CONTROL ROOM HVAC SYSTEM
VALUE IMPACT ASSESSMENT
SEP TOPIC II-1.C, OFFSITE HAZARDS
NUREG-0737, ITEM III.D.3.4
CONTROL ROOM HABITABILITY
SAN ONOFRE UNIT 1
DOCKET NO. 50-206

REVISION 1

Southern California Edison Company

September, 1985

FIGURE 3, SHEET 1

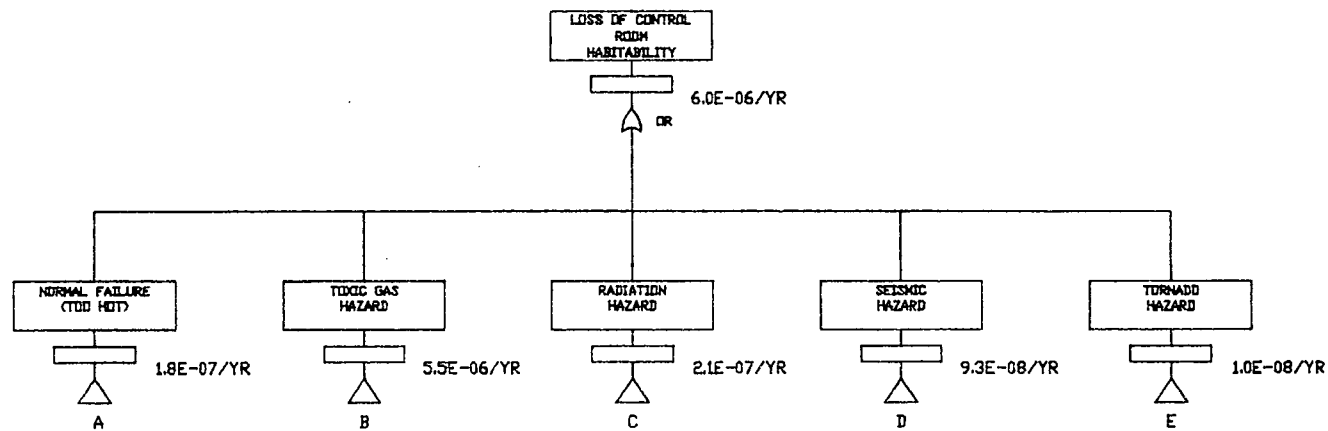
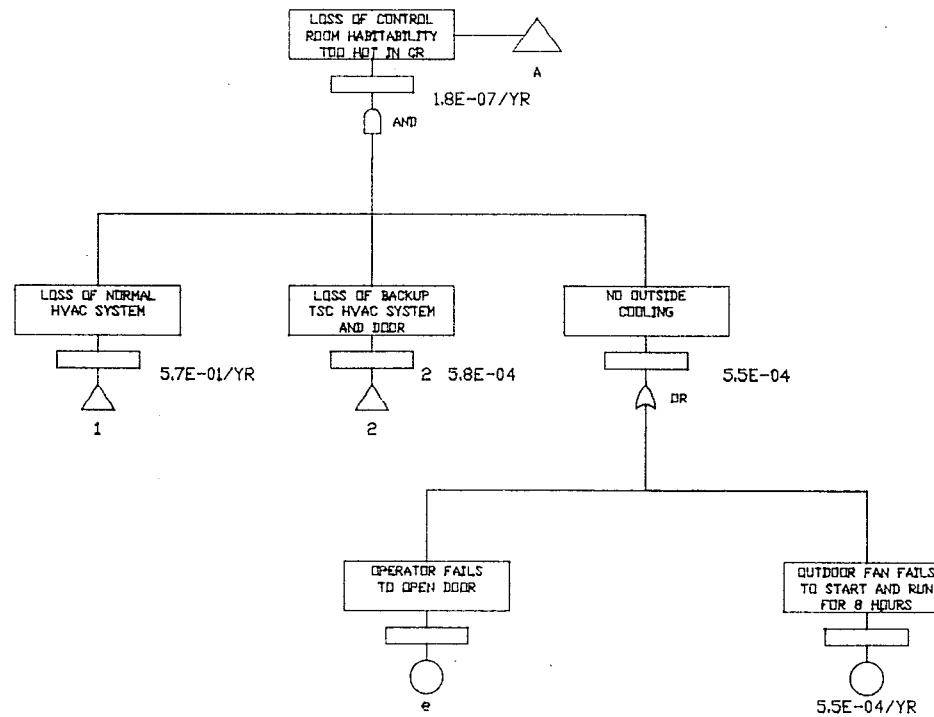
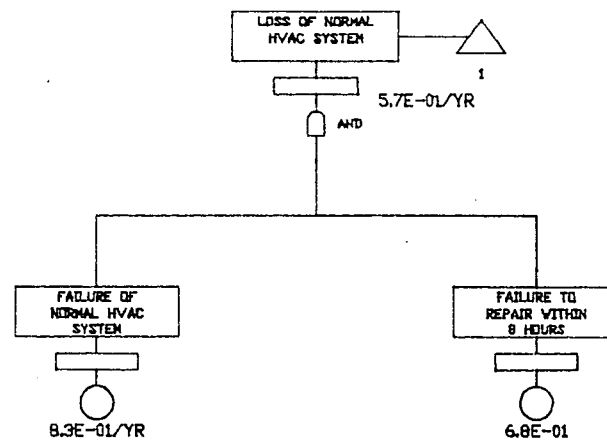
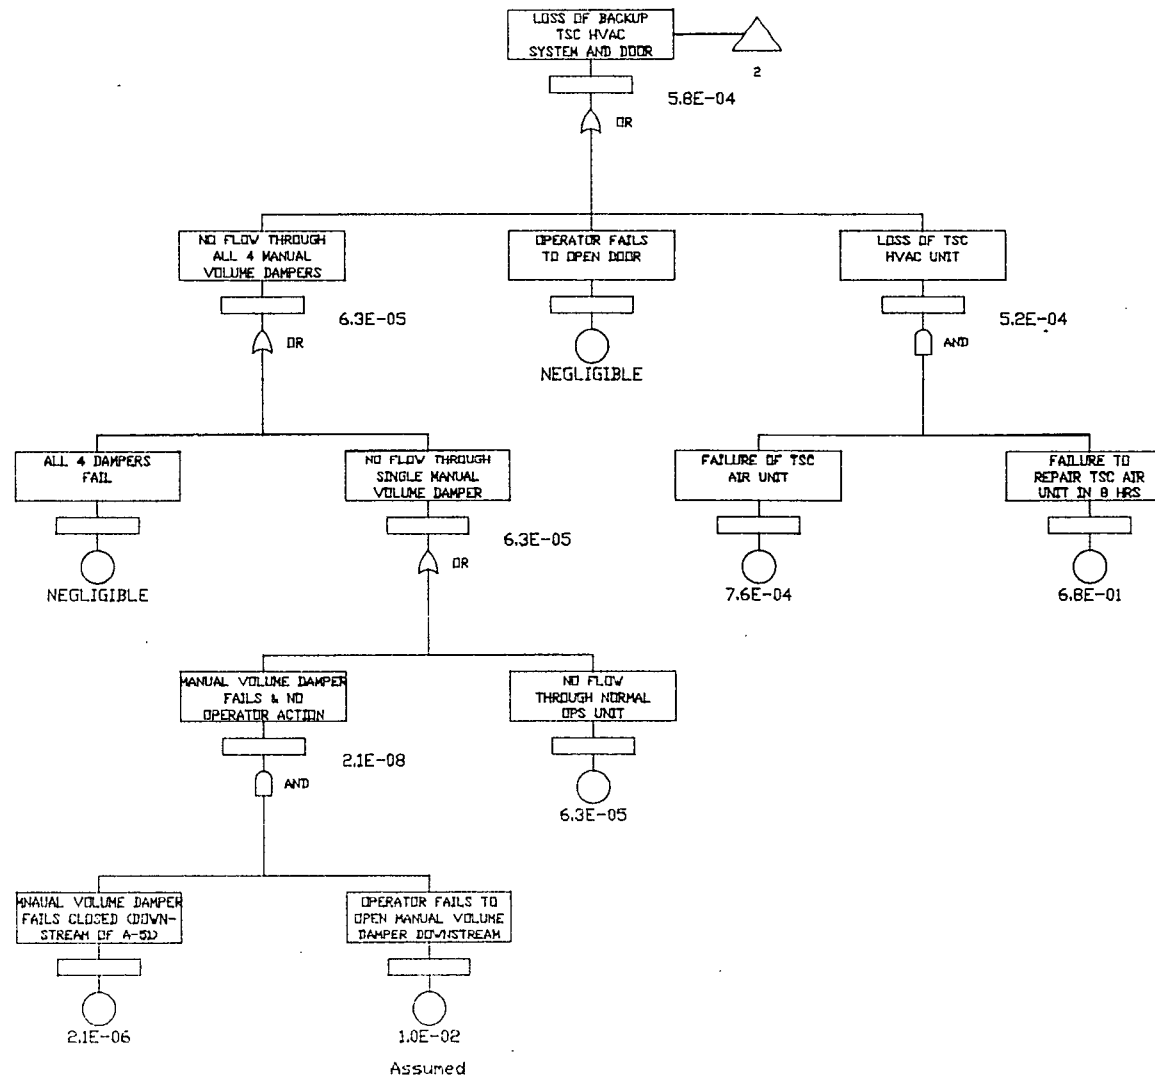
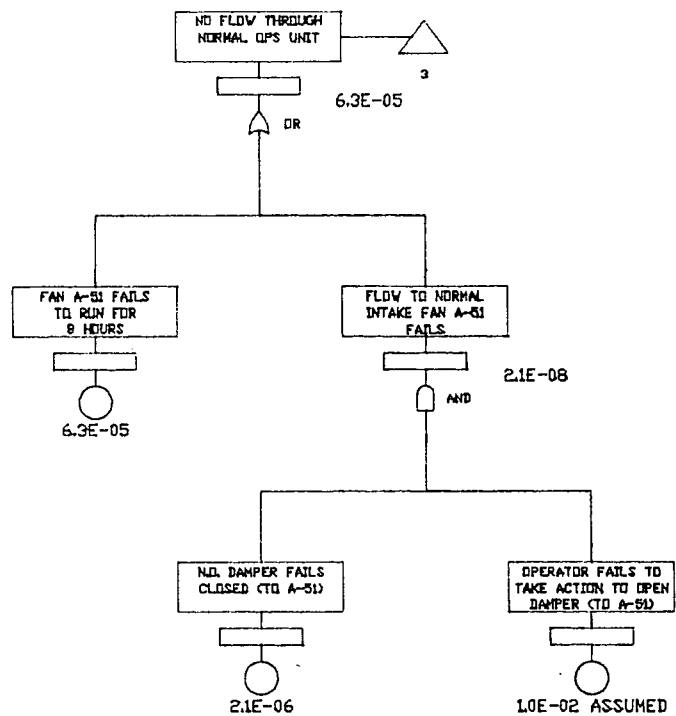
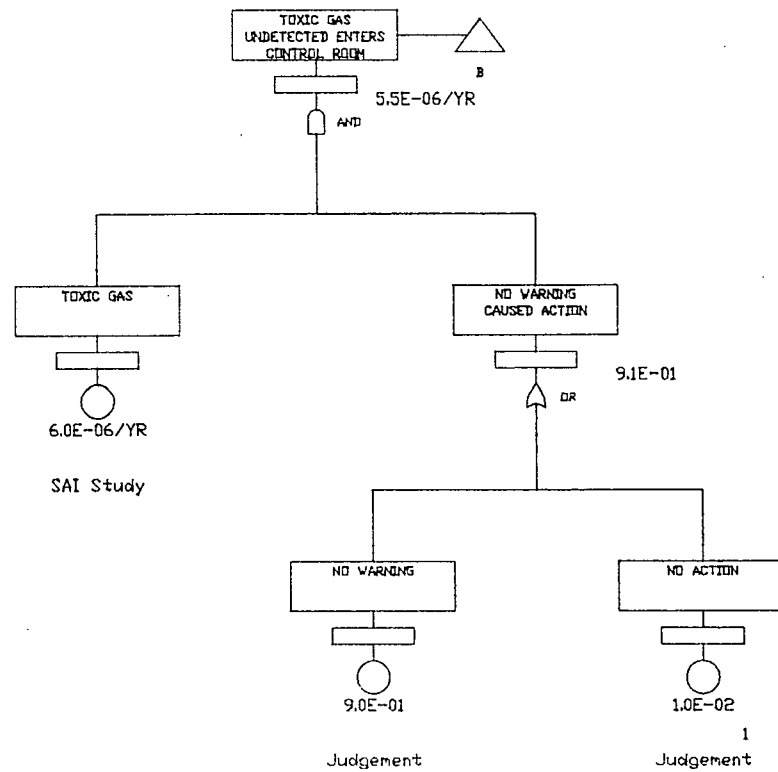
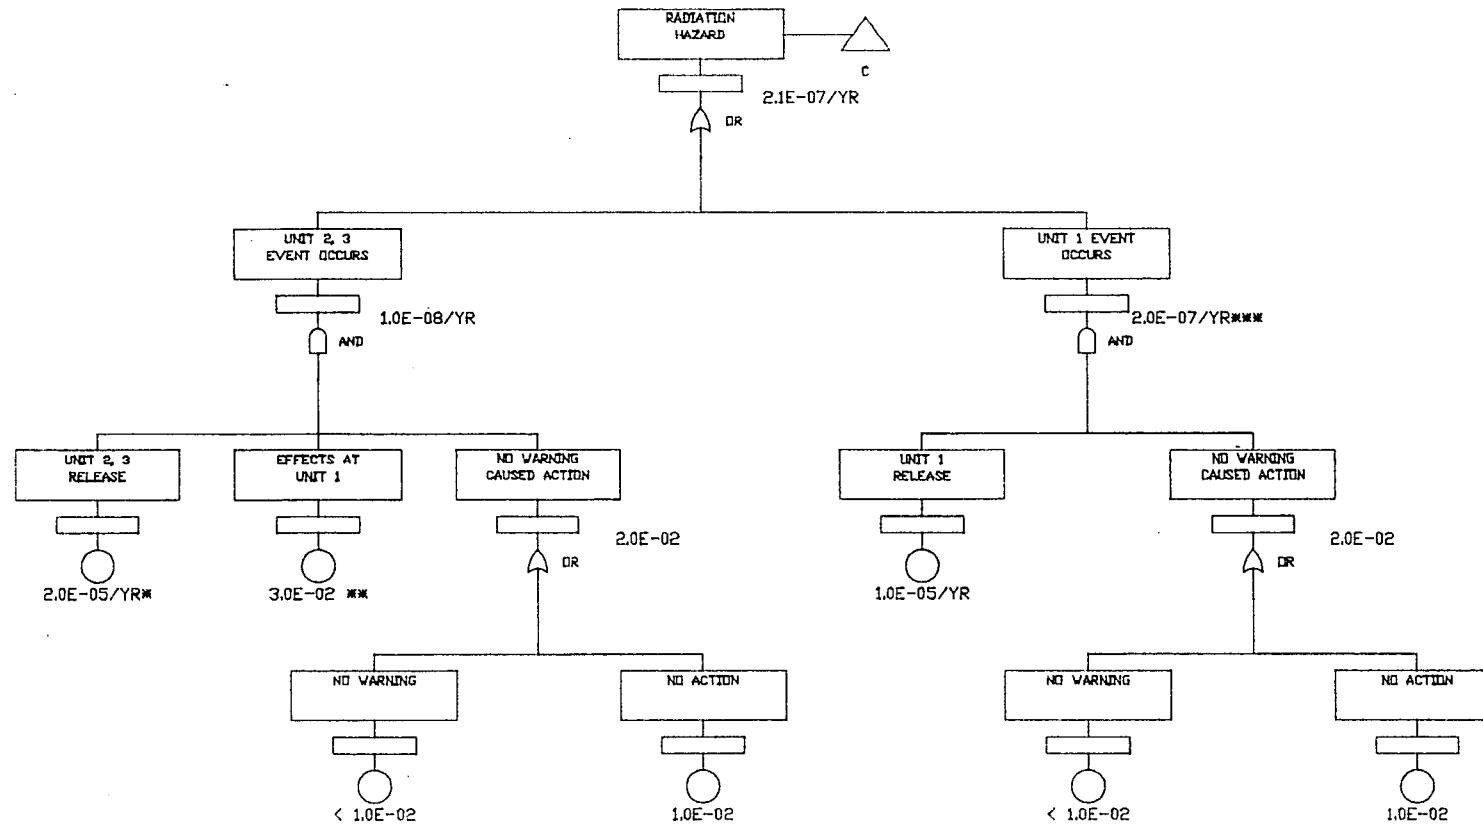
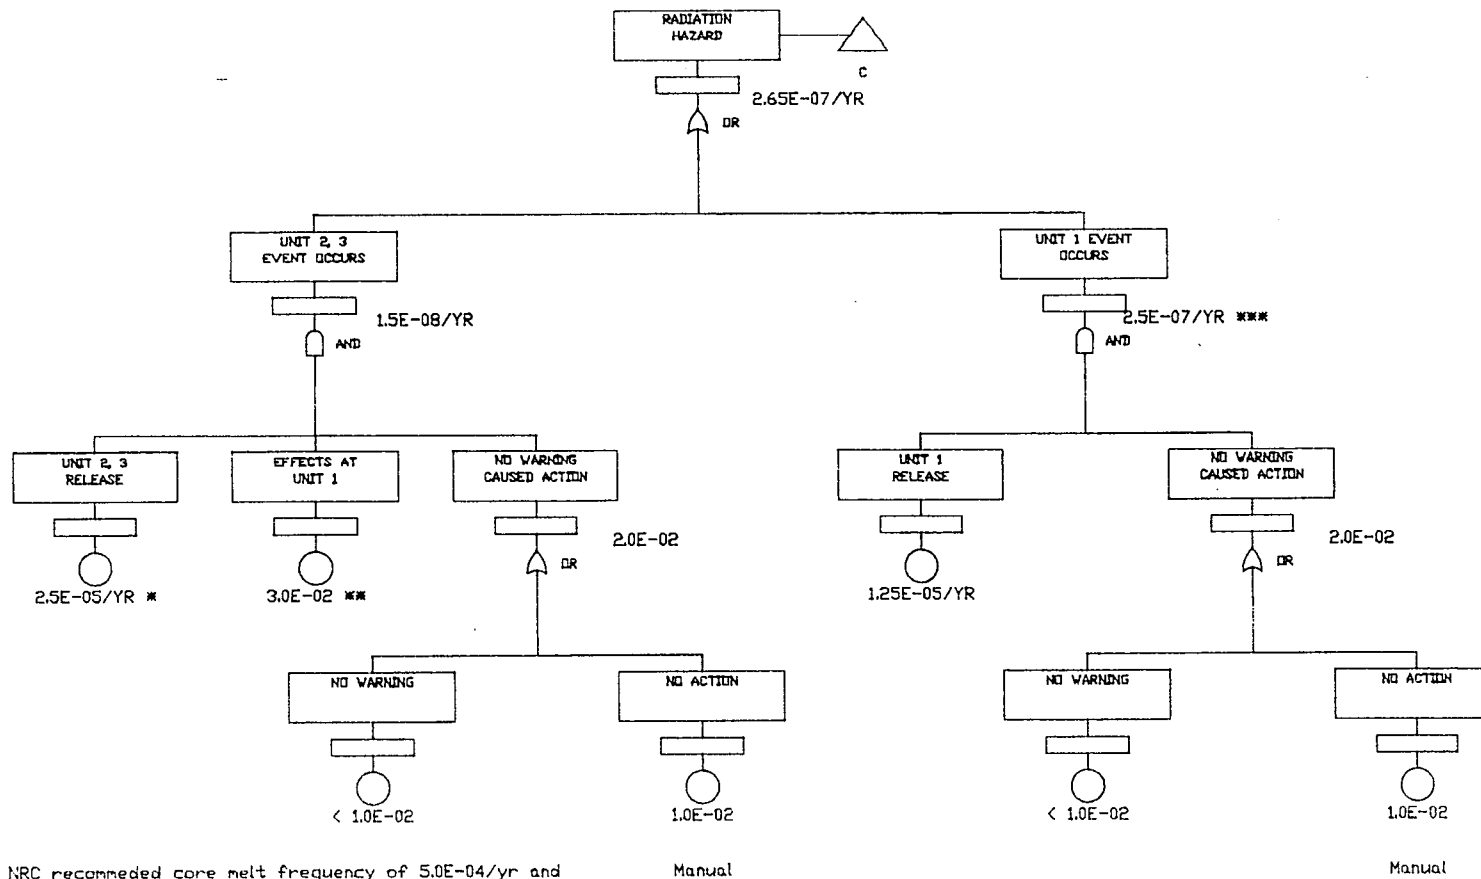
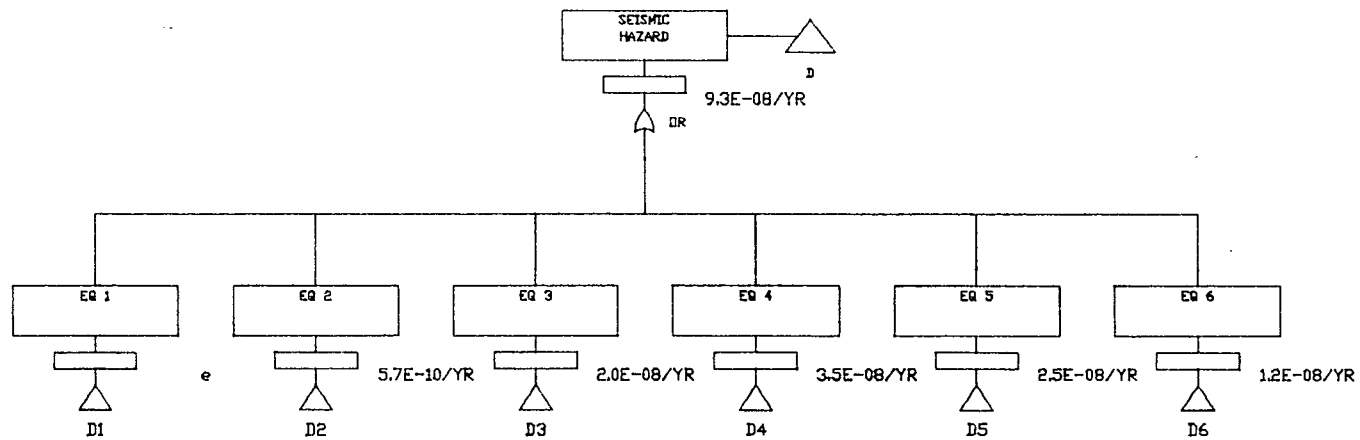
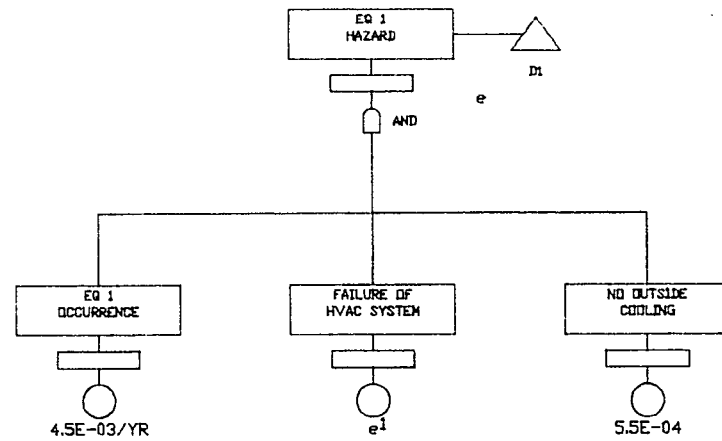
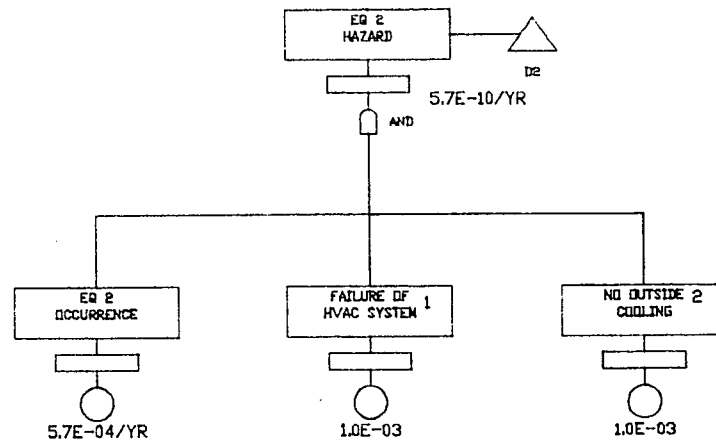
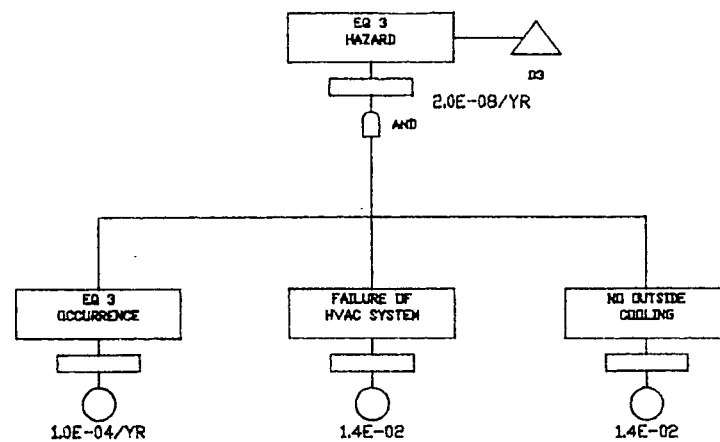
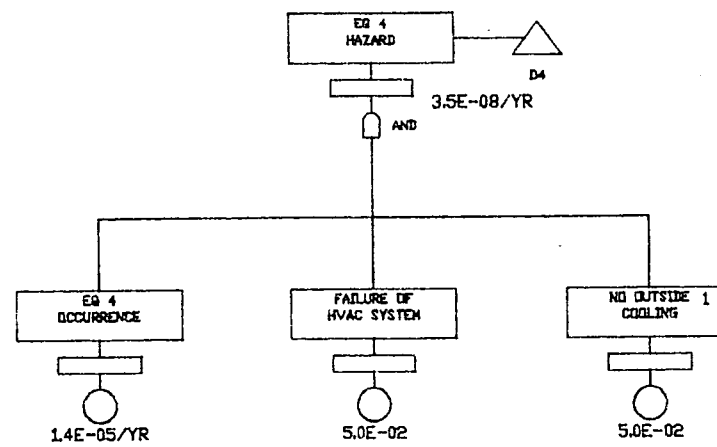
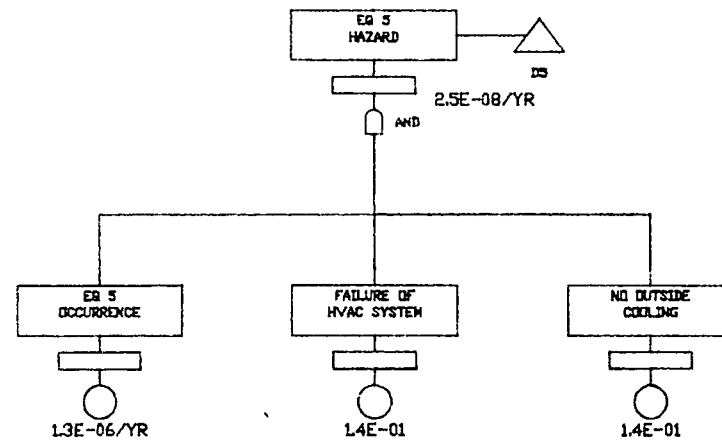
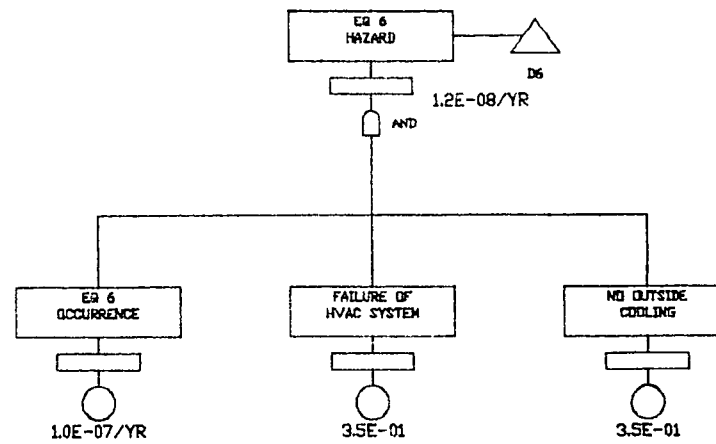
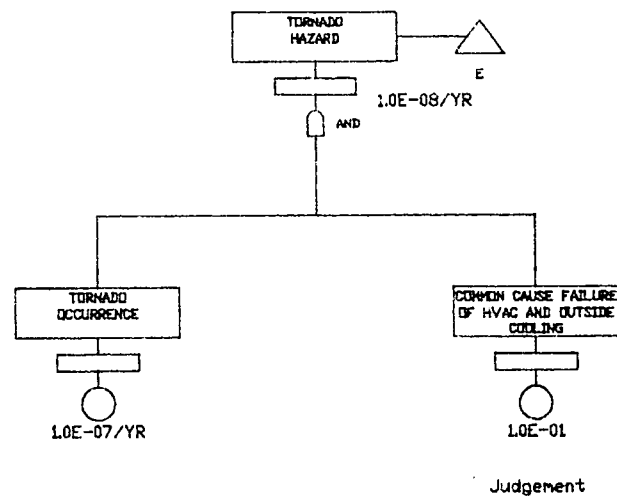
Greater detail is needed in the seismic analysis. It is not at all clear what the seismic hazard assumed for the site is. Figure 9 of Reference 1 (San Onofre submittal) assigned frequencies for the occurrence of different levels of peak ground acceleration (EQ1, EQ2, etc.). However, there is no hint as to what the acceleration ranges associated with EQ1, EQ2, etc., are. The seismic hazard function, with its basis, must be presented. The fragility parameters for the HVAC system are not given, let alone the basis for the fragility parameters. In the simplified SSMRP methodology, it is also necessary to

determine the best-estimate structural response at the location of the component, and the variations of the response. These parameters and their bases were not given.

Response:

The detailed data used in seismic analysis is provided in the revised submittal. The seismic hazard used was plant specific for SONGS 1. The six levels of the earthquakes used in the analysis are:

In addition, the equipment response for each earthquake level is conservatively chosen based on a plant specific assessment performed by Bechtel.
